**16 BARRINGTON STREET
SOUTH SHIELDS
TYNE AND WEAR
NE33 1AN**

SPECIFIC DEFECT SURVEY

FEBRUARY 2026

BS/26/09

Annotated Basement Floor Plan and Elevations

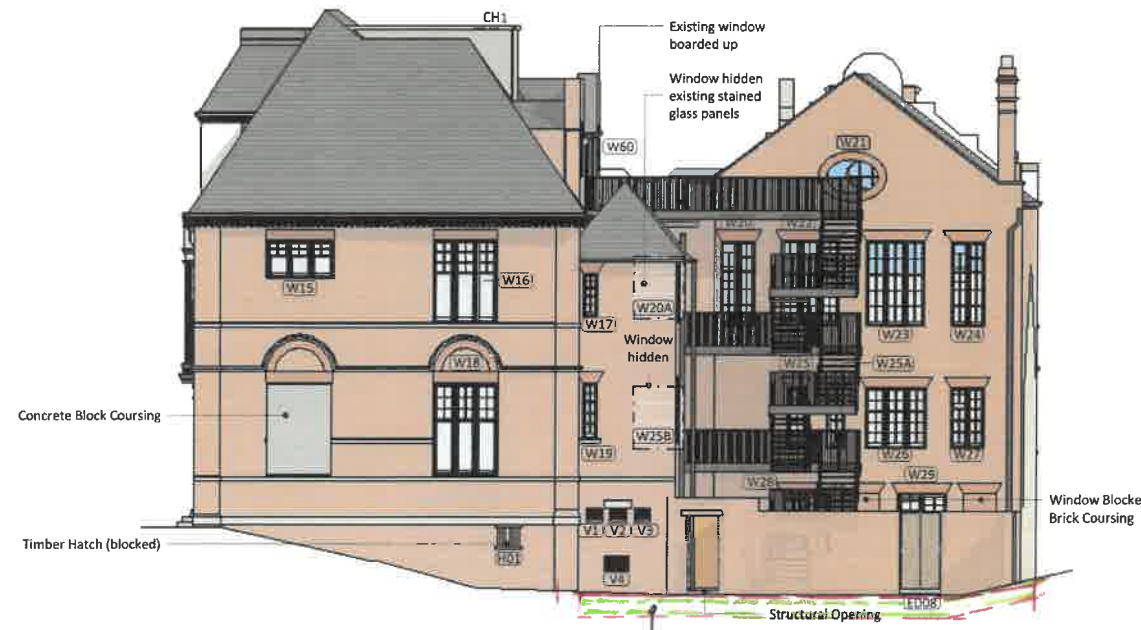
- 1.1.4 For reference purposes please refer to the Proposed Basement Plan in Appendix A which includes further annotation by RNJ Partnership concerning the level of moisture content within the walls and the causes of dampness.

- 2.01 The drawing is titled Basement Plan however the internal finished floor level and the external ground level is such that the floor would be more suitably referred to as a lower ground floor. There is only a limited area which is effectively below the adjoining ground level and this is referred to on the floor plan.

- 2.04 The proposed remedial works referred to by Timberwise on the basement plan indicate electro-osmosis damp proofing, slurry tanking and heavy-duty security mesh to the wall in an isolated areas; they also include for careful removal of plaster of 1 m to full height with plaster mesh membrane to be installed.

- 2.05 An examination and record of moisture content at levels within the walls was taken and these are annotated on the proposed basement plan. It was important to review the external ground conditions and also that of the external wall concurrently with the readings taken within the interior and our findings are presented with reference to the external areas adjoining the room inspected. The findings were as follows:-

- To prevent bridging and the transfer of moisture from the new path directly into the masonry walls it is recommended that a vertical damp proof course (inserted) as an isolating layer between the walls and the path; this is good practice and will minimise the risk of any penetrating dampness. A sketch detail is included in Appendix C and manufacturer's Product Details in Appendix E. It is also advised that a slight cross-fall is incorporated into the path to ensure surface water does not run towards the external wall

Install vertical damp proof membrane collar around the below ground penetrating services

If there is sufficient area i.e. to the south elevation install a 200-250 mm wide gravel margin at a reduced level; this serves as a pre-draining zone between the external wall and the built up ground levels. This detail allows the external ground level to be reduced to ensure it is a minimum of 150 mm below the internal finished floor level. This detail is included in Appendix D. This detail could also be used in conjunction with that indicated in Appendix E for the vertical damp proof membrane

Replacement of the yard wall new gullies and the installation of gravel margin adjacent to the external wall is advised.

- South West corner: rake out the vertical joint between the boundary wall and external wall of the building and insert a vertical damp proof membrane, a flaxcell fibre board and polysulphide mastic joint to isolate the boundary wall from the external wall of the building

P9 – East Elevation services penetration below ground level
Note ground level above finished floor level

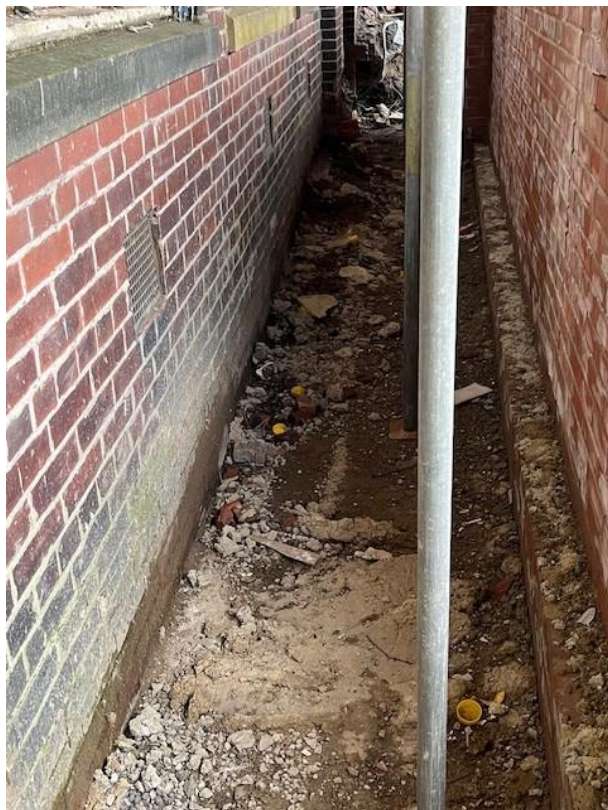
- 2.1.1 Moisture content readings varied with a high of 33% (refer to Photograph P49).
- 2.1.2 Externally it is evident that the external ground level has been lowered and was previously at a higher level (refer to Photograph P12). It is likely that this has resulted in penetrating dampness with moisture migrating through the solid wall construction. The external ground level of the path increased in height on the east elevation towards the north. As a consequence, lower moisture content readings were found in the Estates Room A and B which has reduced external ground levels.

- 2.1.3 Penetrating services in two locations were listed on this elevation and enter the building below ground. A bespoke tanking collar should be introduced around the services penetration to prevent penetrating dampness (refer to Photograph P14).

P46 – Visual evidence of flaking paintwork and damp plasterwork

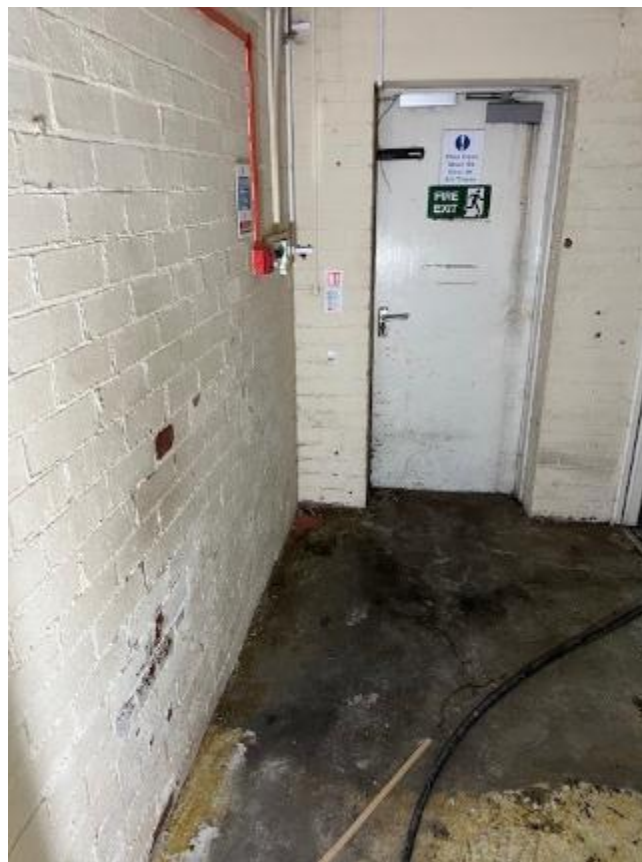
- 2.3.2 It was also noted that the adjoining boundary wall build up against and butting to the corner of the building is potentially forming a bridge which could cause the high moisture levels and dampness at this corner. It is recommended that a vertical damp proof membrane is installed at the interface between the brick boundary wall and the corner of the building and a movement joint installed at this juncture (refer to Photograph P46).

- 2.3.3 Moisture Meter Readings were also recorded on the west facing external wall of the Director of Estates Office and again this faces on to the yard which has flooded and ponded due to inadequate drainage (refer to Photograph P47).

P74 – Potential bridging caused by migration of moisture via plaster in contact with the floor

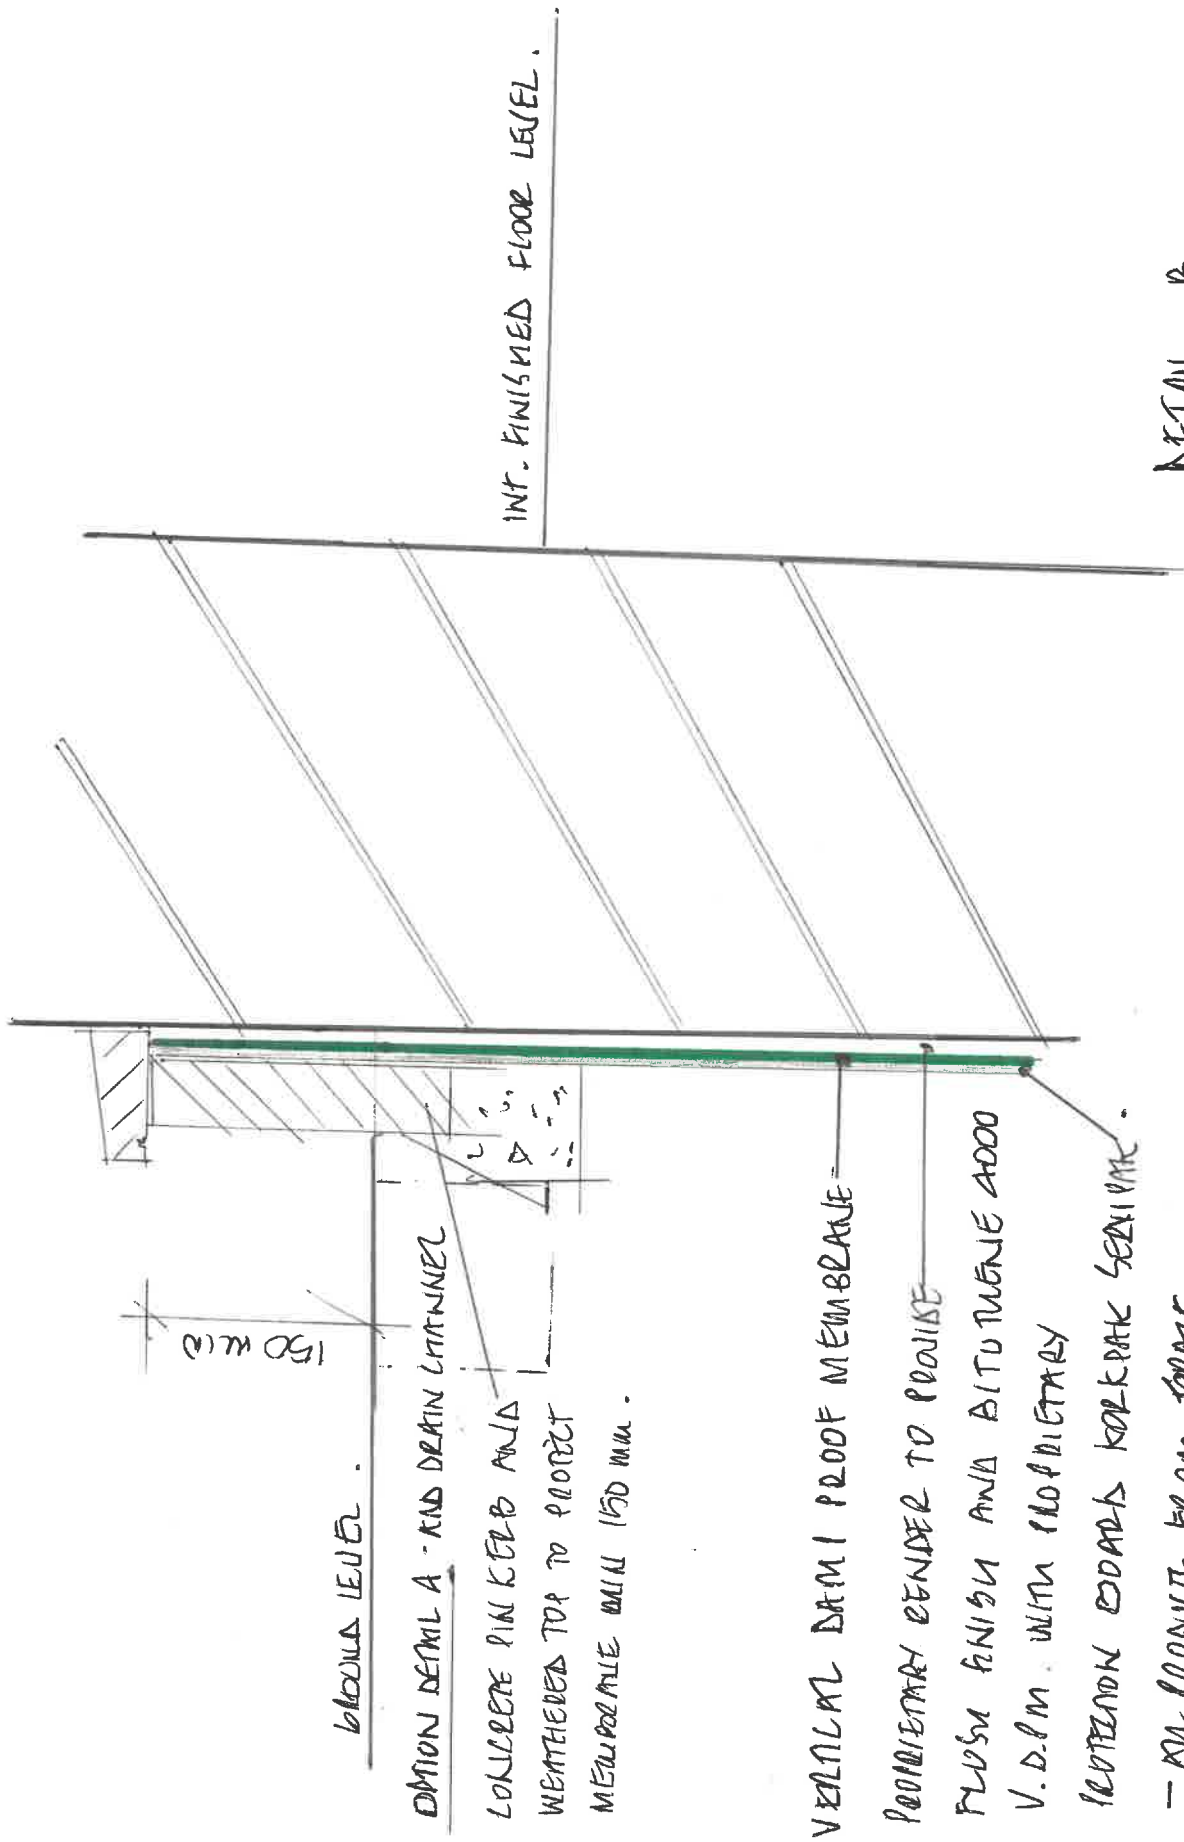
- 2.8.1 The readings taken to these two pillars revealed slightly elevated readings in isolated areas. On the balance of probabilities it is likely that the plaster is in contact with the concrete floor and bridging has resulted in vertical moisture transfer via capillary action to these areas (refer to Photographs P67, P69 and P74).

- 2.8.2 It is recommended that the skirting is removed and the plaster cut back in isolated areas from the floor and repaired in a renovating breathable lime plaster.
